# **Arlington Town Square**

**2018 Approved Signage and Sign Variations**

## Development Identification Canopy Sign at Evergreen Avenue

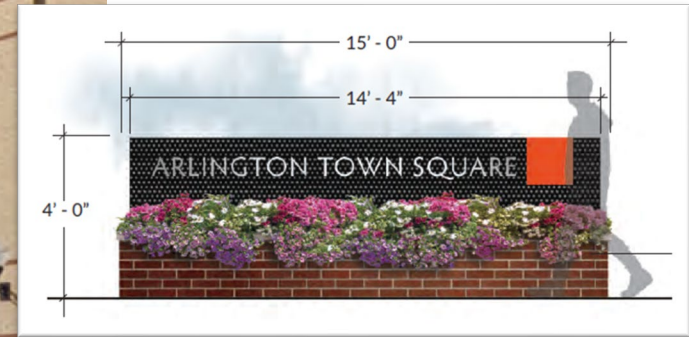
- “ARLINGTON TOWN SQUARE” sign complies with 20% allowed for canopies.
- “PUBLIC PARKING” and small red parking blade signs are exempt as non-advertising signs designed for public safety and convenience.
- Variations not required.

# Entrance Identity Signage on Arlington Heights Road

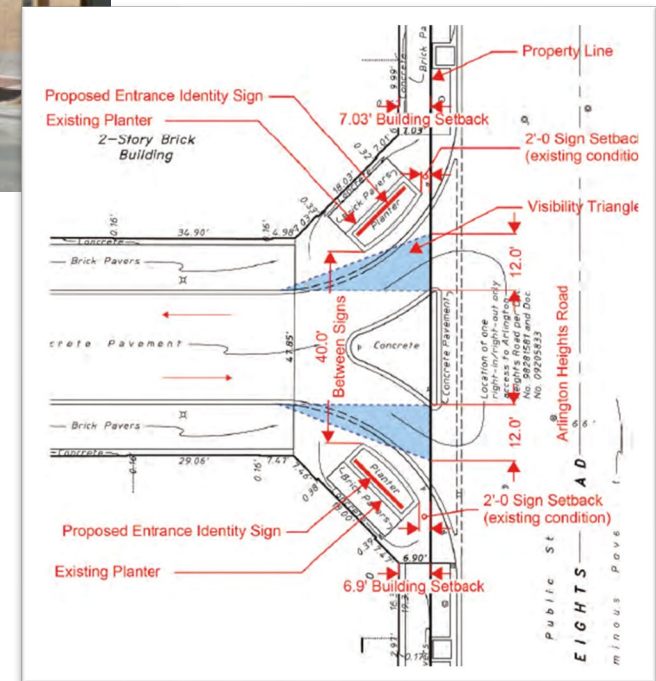
- Two ground signs, where only one is allowed.
- 40 foot separation, where 800 feet is required.

# Office Center Signage

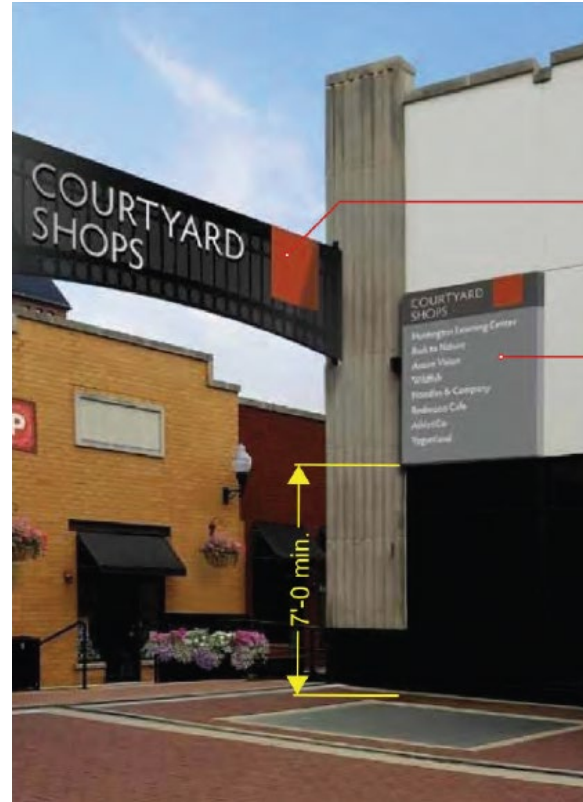
- Signage on top of the canopy, where not allowed to project above
- 30 sf sign, where 4.4 sf is maximum allowed (20%)
